Access Compliance Report Public Rights-of-Way (Curb Ramps)

Main Street: HEWES_AVE Cross Street: ERVIN_LN Location: NE

ADA ID: RPAT211026132106 Ramp Type: Type 4 - Parallel Initial Pass/Fail: Fail Overall Compliance: No Severity Score: 4

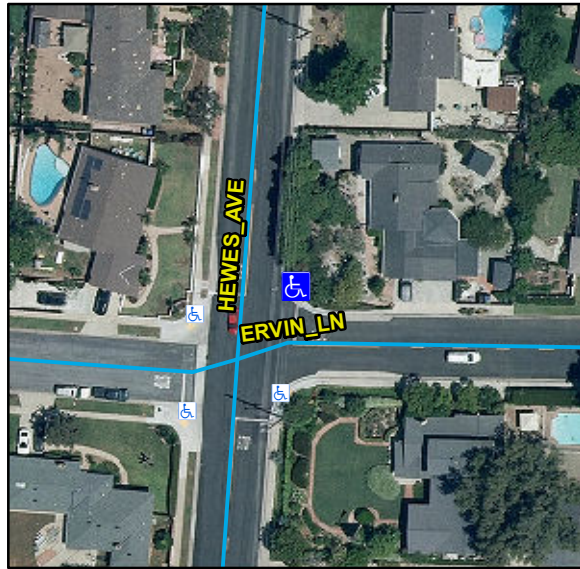
Compliance	Description	Data	Compliance	Description	Data
N/A	Ramp Length LT (in)	84	N/A	Ramp Length RT (in)	72
No	Ramp Width LT (in)	42	No	Ramp Width RT (in)	37
Yes	Ramp Run Slope LT (%)	7.5	Yes	Ramp Run Slope RT (%)	7.5
Yes	Ramp Cross Slope LT (%)	1.1	Yes	Ramp Cross Slope RT (%)	0.3
N/A	Landing Present	N/A	N/A	DWS Provided	N/A
N/A	Landing Length (in)	N/A	N/A	DWS Contrast	N/A
N/A	Landing Width (in)	N/A	N/A	DWS Length (in)	N/A
N/A	Landing Run Slope (%)	N/A	N/A	DWS Full Width	N/A
N/A	Landing Cross Slope (%)	N/A		DWS Offset Type	N/A
N/A	Landing Movement Obstructed?	N/A	N/A	DWS Offset Left (in)	N/A
	Landing Movement Type	N/A	N/A	DWS Offset Right (in)	N/A
N/A	Landing Shared	N/A			
N/A	Clear Space	Yes			
N/A	Clear Space To Crosswalk (in)	N/A			
N/A	Marked Crosswalk 1	No	N/A	Marked Crosswalk 2	No
	Crossing 1 Direction	NW		Crossing 2 Direction	SW
	Marked Crosswalk 1 Width (in)	N/A		Marked Crosswalk 2 Width (in)	N/A

Remove & Replace Curb Ramp With Two New Directional Ramps or Equivalent.
